City of Sugar Hill
Planning Staff Report
Central Business District Overlay (CBD) Design Review 16-01022

DATE: June 29, 2016
TO: Mayor and Council, CBD Design Review Board
FROM: Planning Director *KA*
SUBJECT: Temple Drive/Hillcrest Drive/West Broad Street/ JWM Ventures LLC

APPLICANT: JWM Ventures, LLC
PROPERTY OWNER: City of Sugar Hill
EXISTING ZONING: General Business (BG)
REQUEST: Mixed Use Project – Design Review Approval
PROPERTY SIZE: ± 4.6 Acres, Tax Parcel #7-291-078, 079B, 079, 079A, 080, 130, 193, and 7-292-184
LOCATION: Block of Hillcrest Drive, Nelson Brogdon Boulevard, Temple Drive, and West Broad Street.

TEMPLE DRIVE FACADE

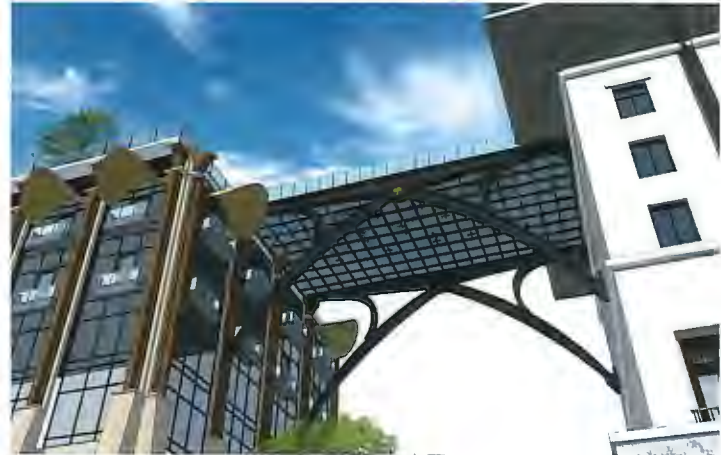
The proposed design is consistent with the adopted design guidelines. The building addresses the sidewalk, provides pedestrian-scale architectural elements and commercial uses at the ground floor on the Temple Drive elevation, includes public gathering areas, and separates parking into a deck.
